UNITED STATES ENVIRONMENTAL PROTECTION AGENCY
REGION 1
1 CONGRESS STREET, SUITE 1100
BOSTON, MASSACHUSETTS 02114-2023

Re: Final Remedial Action Work Plan for the Soil and Sediment Removal at Operable Unit 7
- Area A Weapons Center (Site 20) at the Naval Submarine Base - New London

ATTACHMENT A

FIGURE 4-2
**AREAS OF PROPOSED SELECTIVE
 EXCAVATION FOR ALTERNATIVE 3b
 (RESIDENTIAL LAND USE SCENARIO)**
**SITE 20 - AREA A WEAPONS CENTER
 NAVAL SUBMARINE BASE
 NEW LONDON, CONNECTICUT**

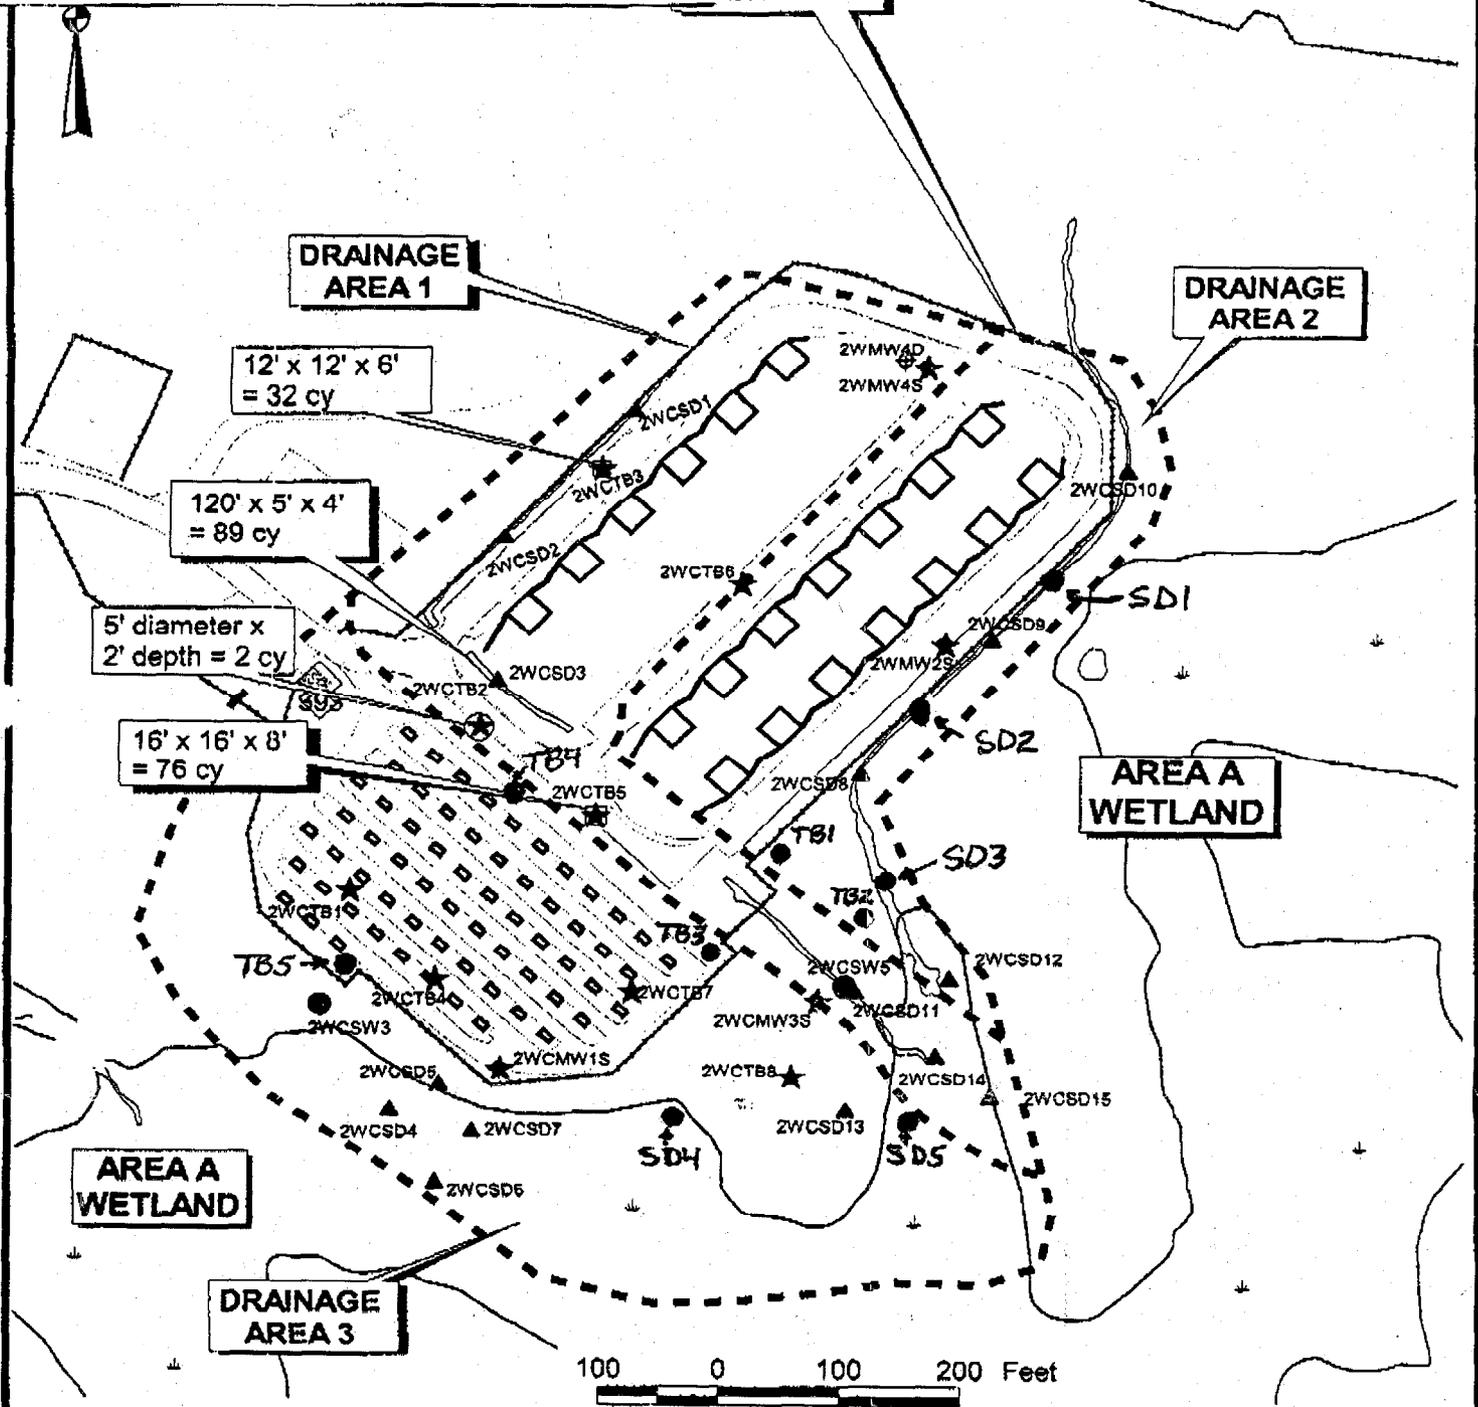
p. 7, §2.3.4, ¶6	This paragraph mistakenly references 2WCTB2 twice. It appears that the reference should be to 2WCTB3 and 2WCSD3. Both of these excavations will apparently intersect the drainage ditch, but excavations at 2WCTB2 and 2WCTB5 apparently will not. Please revise and correct as appropriate.
